REQUEST FOR INFORMATION	DATE: May 12, 2016	NO.: RFI-074
--------------------------------	---------------------------	---------------------

Project Name: Webster University Interdisciplinary Science Building Project No.: 15051

Subject: Curtainwall paint color sample

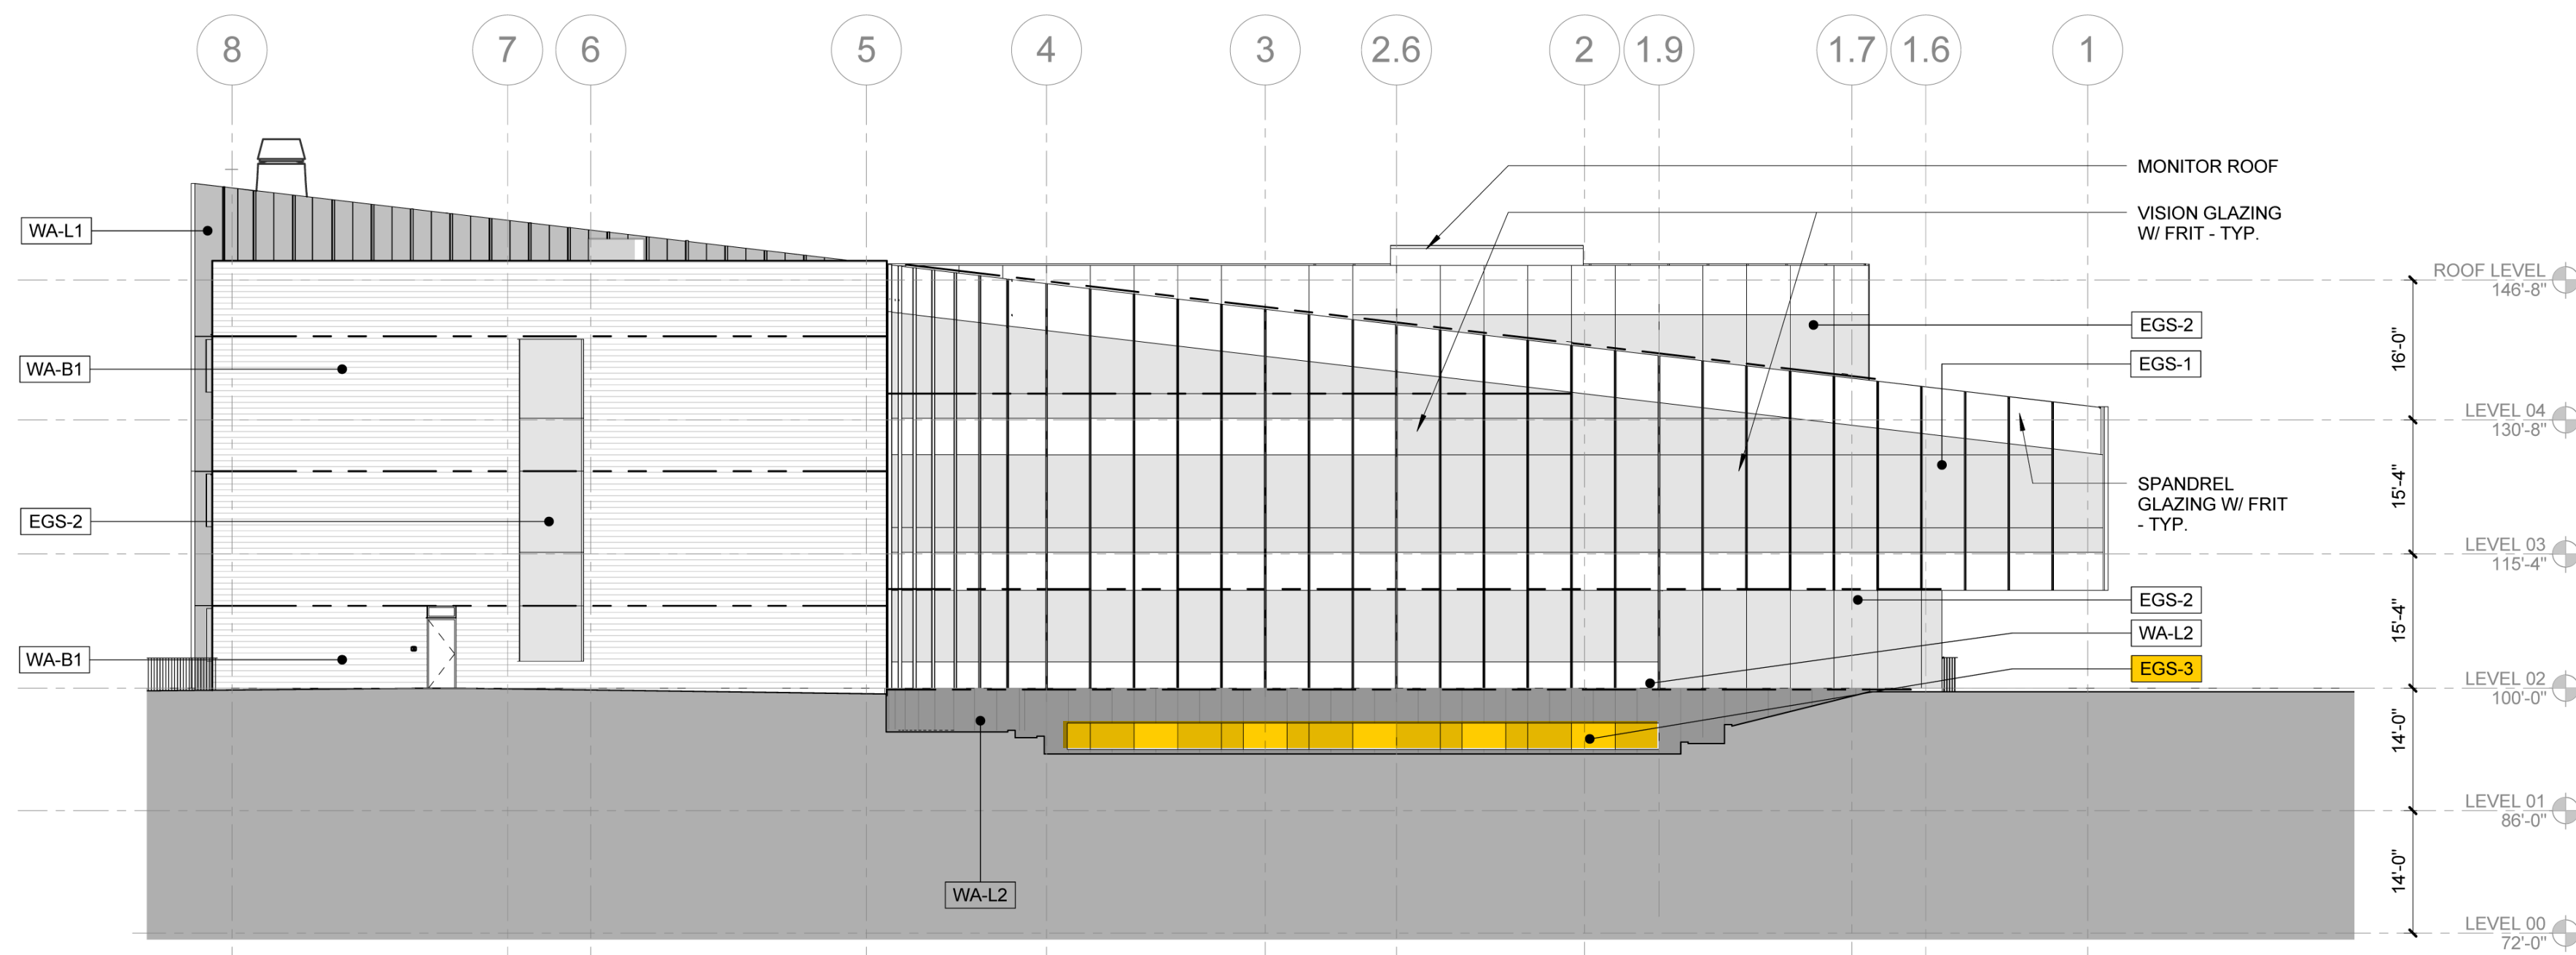
The curtainwall contractor needs color chips of the selected paint finish for the exterior aluminum curtain wall, system EGS-2A. With these chips they can forward to the supplier so it can be matched in a kynar finish and color samples can be issued for formal approval. Will Cannon provide chips?

The specs call for a differing color on the mullions for this system. Does the color selected apply to the horizontal rails too?

EGS-2A (curtain wall at the sunken courtyard including lecture hall) & EGS-3 (Punched windows at the north area well) are to be black in color.

This color applies to the entire curtain wall system, including the doors within it (see yellow highlighted area of attachment).

Provide manufacturer's standard black color samples for selection.
